Gunlake Quarry Continuation Project

Responses to information requests

Prepared for Gunlake Quarries Pty Ltd

J210263 RP#25

Figure 2.1 Deposited Plan 700290 extract showing TfNSW road corridor

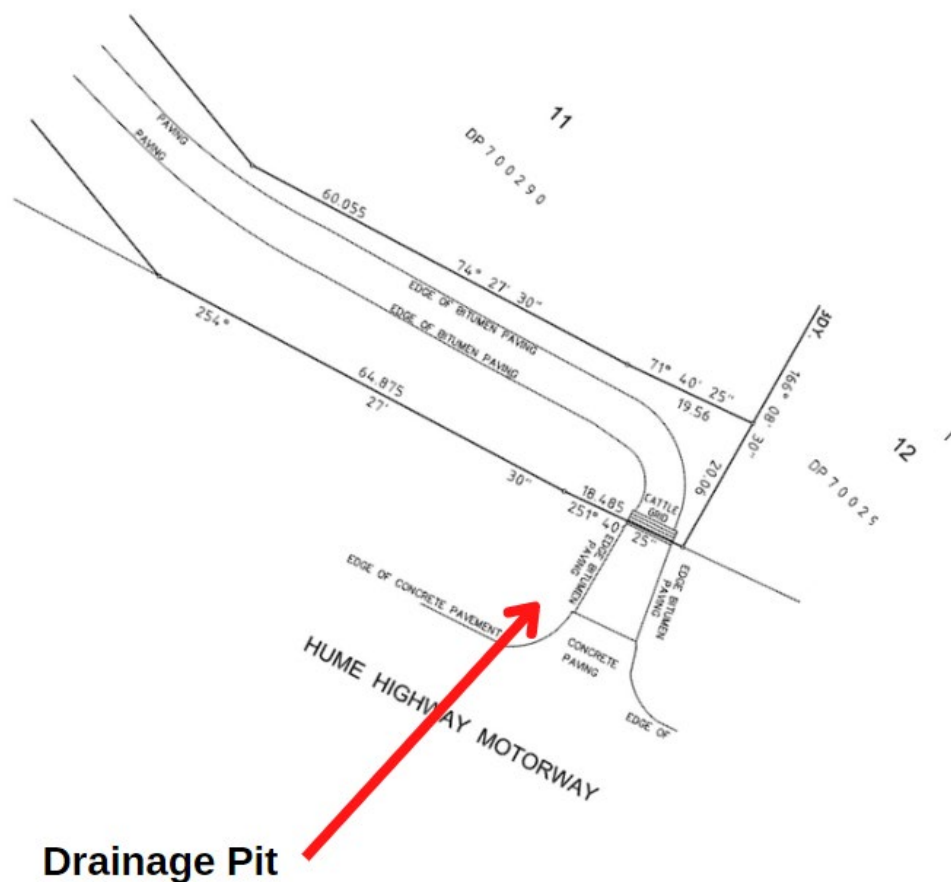
In its 31 May 2022 letter, TfNSW noted that it considers that trucks are “departing the Hume Highway via Red Hills Road cutting the corner (southern side of the Red Hills Road/Hume Highway intersection) and damaging existing infrastructure within the road reserve (e.g. existing pits, etc)”; that the increased truck movements associated with the Continuation Project would increase this damage; and that it is not TfNSW’s responsibility to maintain the intersection/repair damage as a result of larger vehicles traversing outside the painted edge line. TfNSW believes that Gunlake must identify measures to stop/prevent heavy vehicles departing the Hume Highway via Red Hills Road cutting the corner.

In its 28 July 2022 letter, TfNSW noted that while their 31 May 2022 comments generally apply, that TfNSW consider that the inside of the corner where damage has occurred is:

Bitzios (2022) recommend an assessment of the increase in traffic (and potential changes to vehicle size) on the geometric design for this intersection, including methods to mitigate the impact of vehicles cutting the corner when turn left from Hume Highway.

The land section is clearly owned by TfNSW as is evident in Deposited Plan 700290 (Figure 2.1).

The propensity for trucks to leave the travelling lane is dependent on the geometry of the intersection and the truck type. While the number of quarry-related trucks using the intersection will increase as a result of the Continuation Project, there will be no change to the types of trucks as a result of the Continuation Project.

In 2017/18, Gunlake designed and upgraded this intersection in consultation with Roads and Maritime Services (RMS). The intersection design applied the Austroads Design Vehicles and Turning Path Templates and was approved by RMS. Additional measures were installed to prevent trucks cutting the corner and leaving the travel lane as agreed with RMS. Although some damage to the shoulder and guideposts is evident, Gunlake do not believe that this damage was caused by Gunlake Quarry trucks.

The intersection geometry was approved by RMS/TfNSW based on quarry truck usage. The increase in truck numbers as a result of the Continuation Project will not change the path of trucks through the intersection. Further assessment of the intersection geometry as part of the assessment of the Continuation Project is therefore not warranted.

Figure 2.2 Future (2051) cumulative traffic volumes

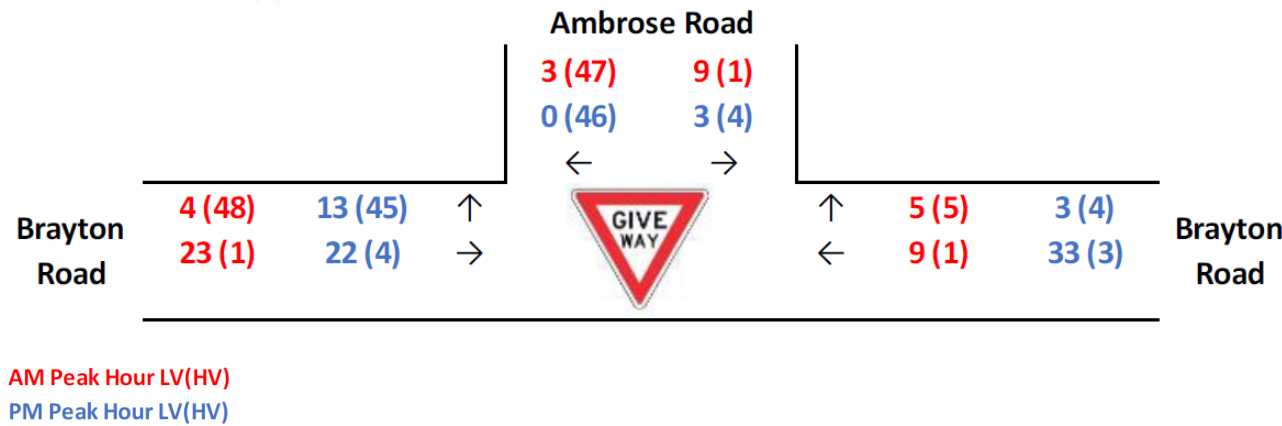
Bitzios (2022) recommend an intersection capacity assessment of the Brayton Road/quarry access road intersection.

The future (2051) cumulative traffic volumes (ie Gunlake Quarry traffic plus all non-Gunlake Quarry traffic) are shown in TIA Figure 5.9. The traffic volumes on Brayton Road between the quarry and the Brayton Road/Ambrose Road intersection are shown in Figure 2.2 below.

There are low non-Gunlake Quarry traffic volumes on this section of Brayton Road. As there are no intersections between the Quarry and Ambrose Road, the traffic volumes shown in Figure 2.2 can be used to determine through traffic at the Brayton Road/quarry access road intersection. For example, it is predicted that there will be 27 light vehicles (4+23) and 9 heavy vehicles (48+1-40) southbound through traffic during the whole of the morning peak hour (about one southbound vehicle every two minutes). Given the low number of movements on each leg of the Brayton Road/private quarry access road intersection, the intersection SIDRA modelling was not warranted for this intersection as it is clear that this has ample capacity.

Figure 2.3 Culvert locations

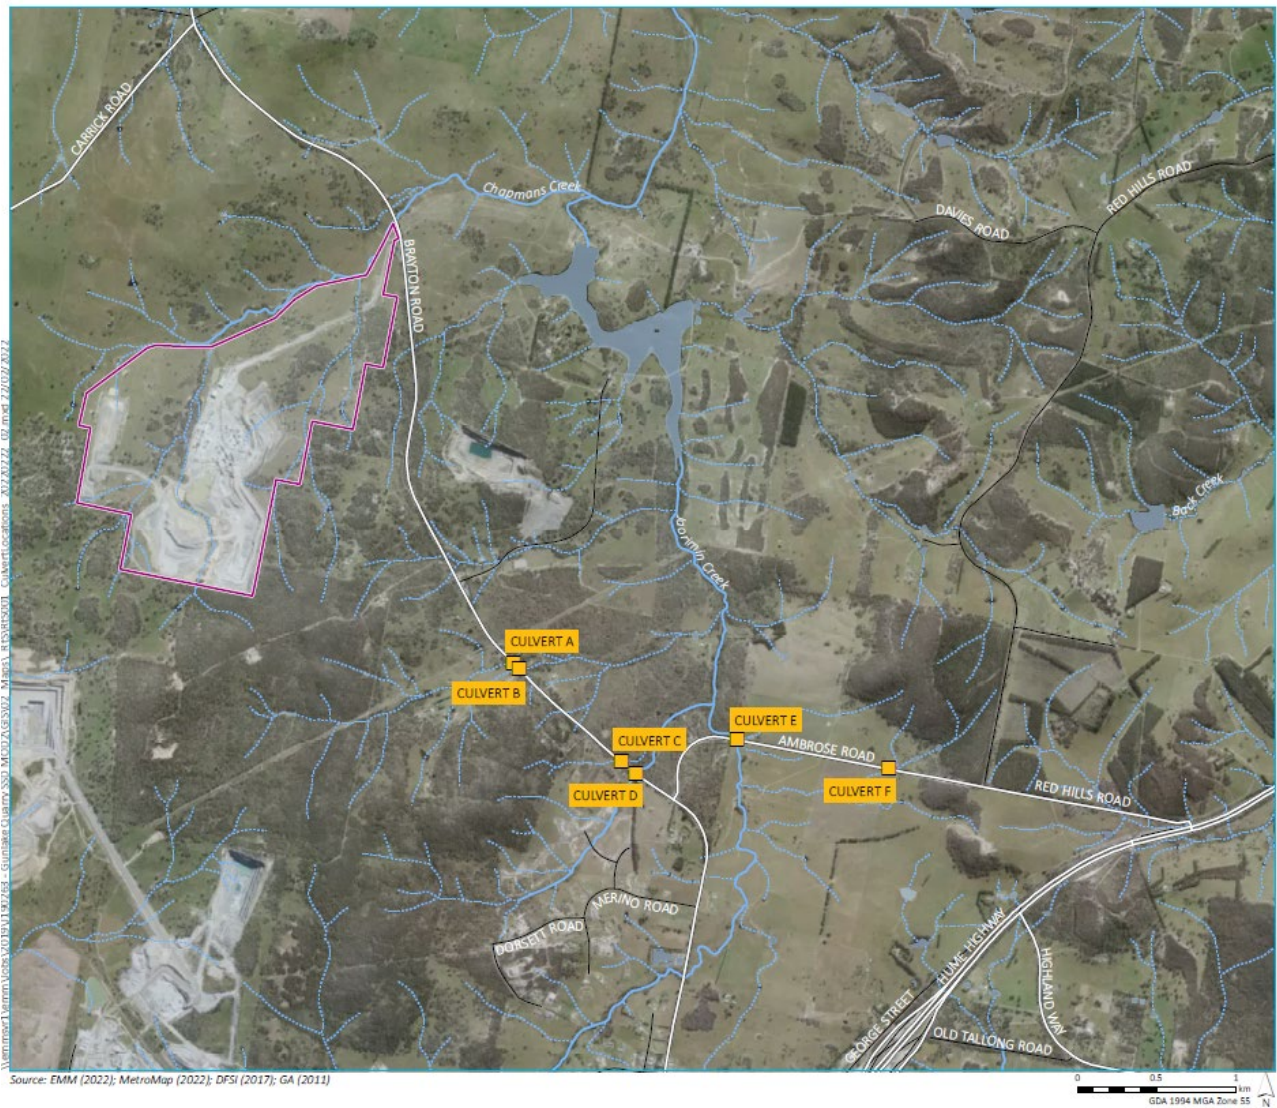
Gunlake have committed to widening Culverts A to E. This approach is supported in Section 5.2 of the independent review commissioned by DPE (Bitzios 2022) that recommends that widening of Culverts A–E (not Culvert F) is imposed as a consent condition. However in Section 5.2, Bitzios (2022) also recommend that "[f]urther justification should be provided by the applicant as to why the WCLT [wide centre line treatment] is not extended through Culvert F".

Council request that DPE impose a condition requiring Culverts A–F to be widened.

It is proposed to widen Culverts A to E (culvert locations are shown in Submissions Report Figure 3.1 which is replicated in Figure 2.3 below) as part of the Gunlake Quarry Continuation Project to allow the WCLT to be extended across these culverts. The additional sections of WCLT are described below along with an explanation of why there would be negligible benefit from widening Culvert F.

It is proposed to widen Culverts A–E along the Primary Transport Route (see Section 3.2 of the Submissions Report) to allow the WCLT to continue across these culverts (Table 2.1). Widening the culverts will provide an additional 700 m WCLT along the Primary Transport Route.

As the WCLT does not extend up the steep incline on Ambrose Road, widening of Culvert F would only allow the WCLT to be extended across the culvert itself which would be of little benefit. This position is supported by Bitzios (2022) which states in Table 4.3:

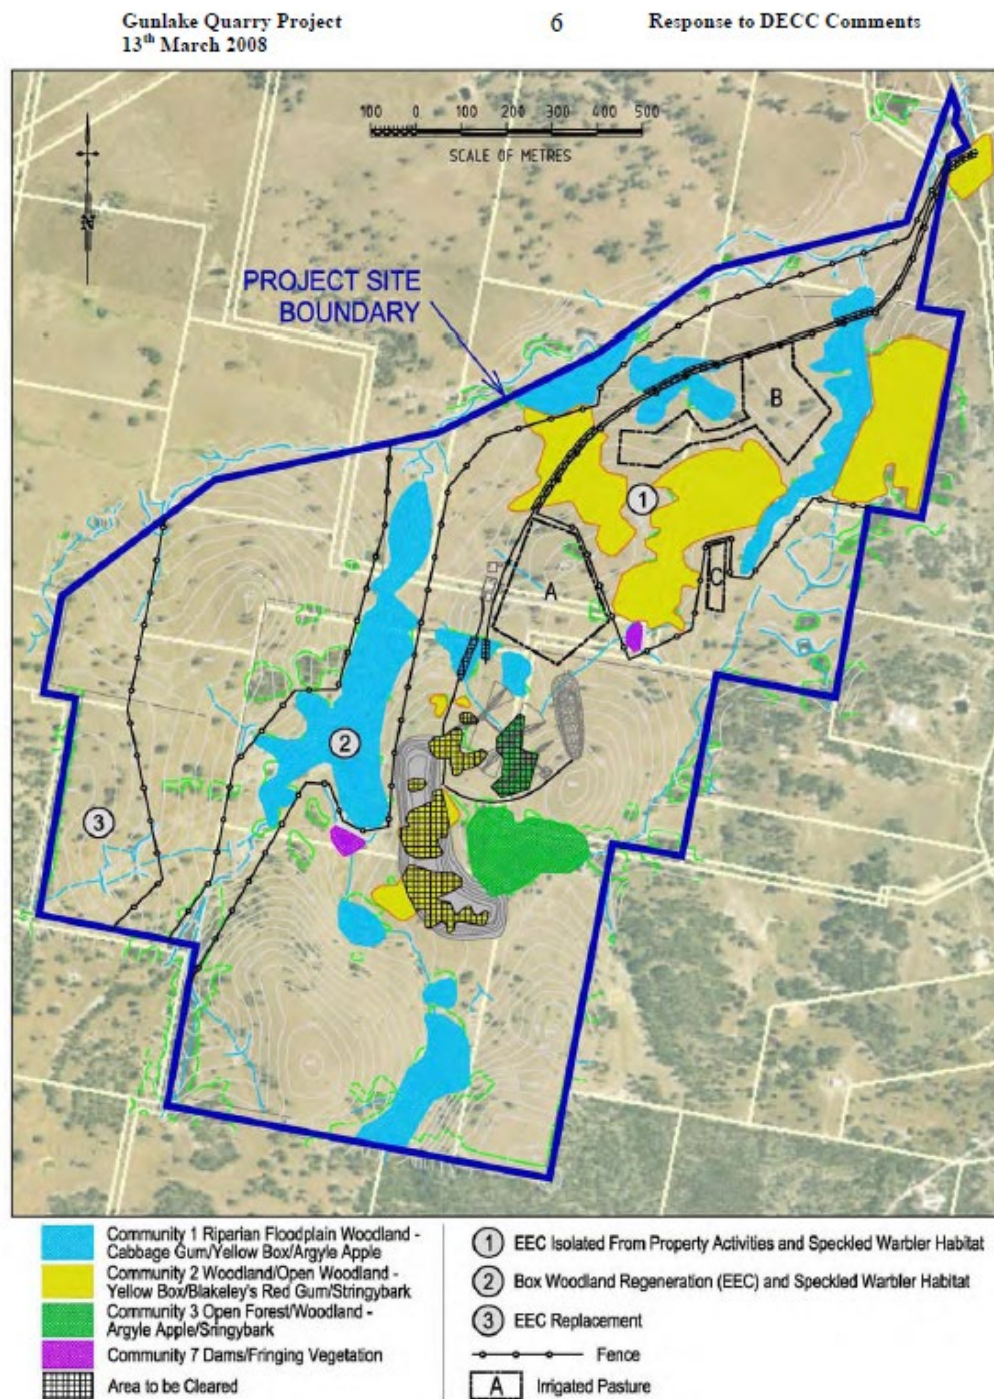
DPE-BCS comment that Gunlake have not addressed why Area A has been cleared.

quarry Response to Submissions report (Olsen 2008) did not map native vegetation in Area 1 (see Figure 1 – reproduced below). Regardless, the original Part 3A approval for the quarry provided a biodiversity offset package to compensate for all vegetation impacts of the original quarry.
